# UNITED STATES PATENT AND TRADEMARK OFFICE

APPLICATION NO.	FILING DATE	FIRST NAMED INVENTOR	ATTORNEY DOCKET NO.	CONFIRMATION NO.
10/675,050	09/30/2003	Zenko Gergintschew	WMP-IFT-823	5870
24131	7590	10/19/2005	EXAMINER	
LERNER AND GREENBERG, PA P O BOX 2480 HOLLYWOOD, FL 33022-2480			PATEL, DHARTI HARIDAS	
			ART UNIT	PAPER NUMBER
			2836

<b>Office Action Summary</b>	<b>Application No.</b> 10/675,050	<b>Applicant(s)</b> GERGINTSCHEW, ZENKO	
	<b>Examiner</b> Dharti H. Patel	<b>Art Unit</b> 2836

DETAILED ACTION

FIG. 1  
PRIOR ART

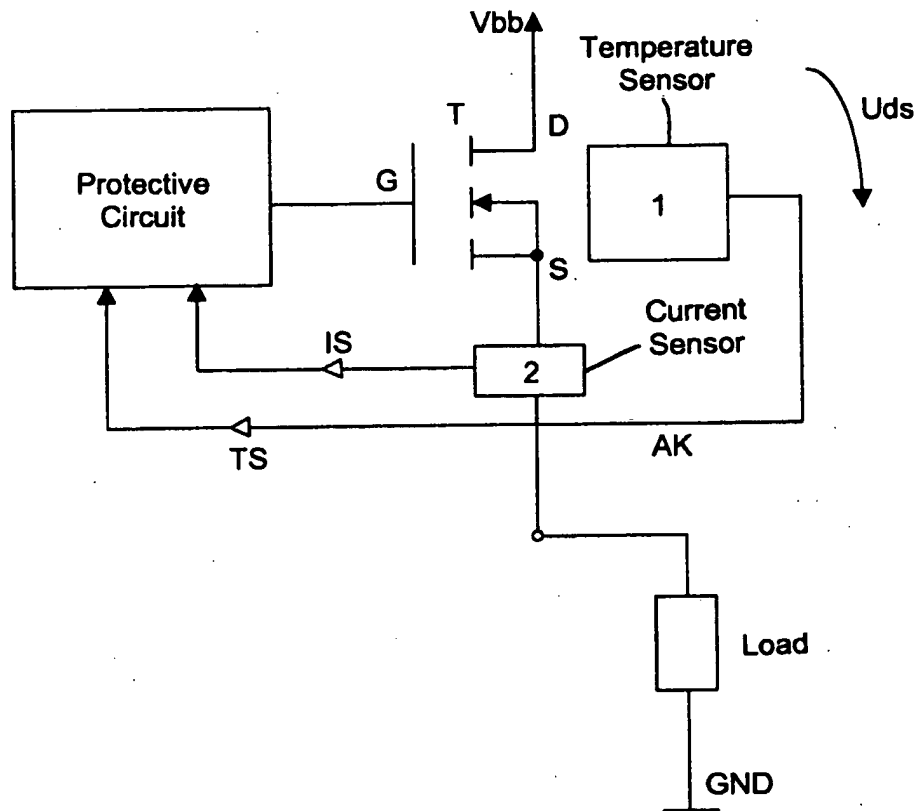
1. Claims 1-4 are rejected under 35 U.S.C. 103(a) as being unpatentable over the acknowledged prior art, in view of Balakrishnan et al., Patent No. 6,781,357. With respect to claim 1, applicant's prior art (Fig. 1 and Fig. 2A) teaches a method for driving a semiconductor switch and circuit configuration with a semiconductor switch. A method comprises a semiconductor switch T having load current limiting (current sensor 2) and thermal protection (temperature sensor 1), the semiconductor switch T switching off upon a predetermined upper temperature T<sub>so</sub> being exceeded and switching on again when a chip temperature falls below a predetermined lower temperature T<sub>su</sub> as disclosed in specifications page 11, lines 18-26 and Fig. 2A; operating the semiconductor switch in one of a normal mode (semiconductor switch is on) and a fault mode (semiconductor switch is off); operating the semiconductor switch in the fault mode upon exceeding the predetermined upper temperature T<sub>so</sub> as disclosed in specifications, page 11, lines 18-20.

3. Claim 6 is rejected under 35 U.S.C. 103(a) as being unpatentable over the acknowledged prior art, in view of Brown, Patent No. 5,757,203. With respect to claim 6, applicant's prior art (Fig. 1) teaches a method for driving a semiconductor switch and circuit configuration with a semiconductor switch. A method comprises a semiconductor switch T having a drive terminal and a load path; a protective circuit connected to the drive terminal of the semiconductor switch T; a temperature sensor 1 disposed in a region of the semiconductor switch T and coupled to the protective circuit, temperature sensor 1 providing a temperature measuring signal TS fed to the protective circuit; and a current measuring configuration 2 coupled to the protective circuit and generating a current measuring signal IS being dependent on a current across the load path of the semiconductor switch as disclosed in Fig. 1.

The following is an examiner's statement of reasons for indicating allowance: With respect to claim 7, applicant's acknowledged prior art (Fig. 1) teaches a method for driving a semiconductor switch and circuit configuration with a semiconductor switch, but does not teach a protective circuit storing first and second overtemperature signals, and, depending on the mode, said protective circuit drives said semiconductor switch into a blocking state according to a comparison of the temperature measuring signal to the first overtemperature signal or according to a comparison of the temperature measuring signal to the second overtemperature signal. This is not anticipated or rendered obvious by the prior art reference.

With respect to claim 8, applicant's acknowledged prior art (Fig. 1) teaches a method for driving a semiconductor switch and circuit configuration with a semiconductor switch, but does not disclose a voltage measuring configuration for detecting a load path voltage of said semiconductor switch and connected to said protective circuit, said voltage measuring configuration providing a voltage measuring signal that is fed to said protective circuit, said protective circuit assumes one of the first and second modes depending on the voltage measuring signal. This is not anticipated or rendered obvious by the prior art reference.

FIG. 2A  
PRIOR ARTFIG. 2B  
PRIOR ARTFIG. 2C  
PRIOR ARTFIG. 2D  
PRIOR ART

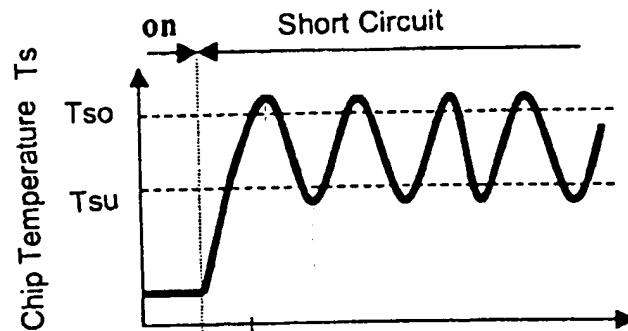
temperature falls below the predetermined lower temperature  $T_{su}$  in the normal mode and in the fault mode as disclosed in specifications page 11, lines 18-26 and Fig. 2A.
